BC BUILDING and PLUMBING CODE 2018

CODE CHANGE REVISIONS

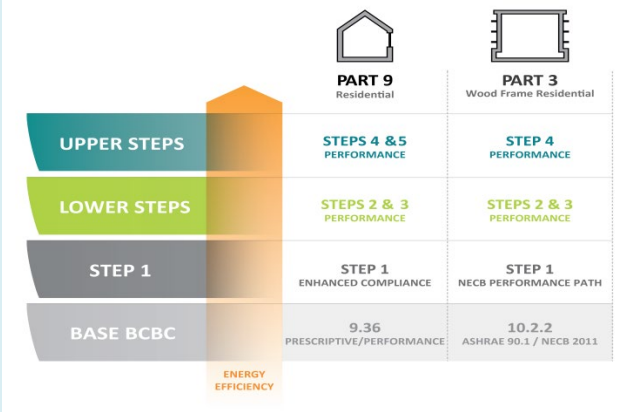
9.23.6.1			x	Anchorage of Building Frames: For frame buildings in areas where the seismic acceleration, $S_a(0.2)$, is greater than 0.70 but less than 1.8 and the 1-in-50 hourly wind pressure (HWP) is not greater than 1.20 kPa, anchorage shall be provided by fastening the sill plate to the foundation in accordance with new Table 9.23.6.1. Anchor Bolt Spacing where the 1-in-50 $HWP \leq 1.20$ kPa and $0.70 < S_a(0.2) \leq 1.8$
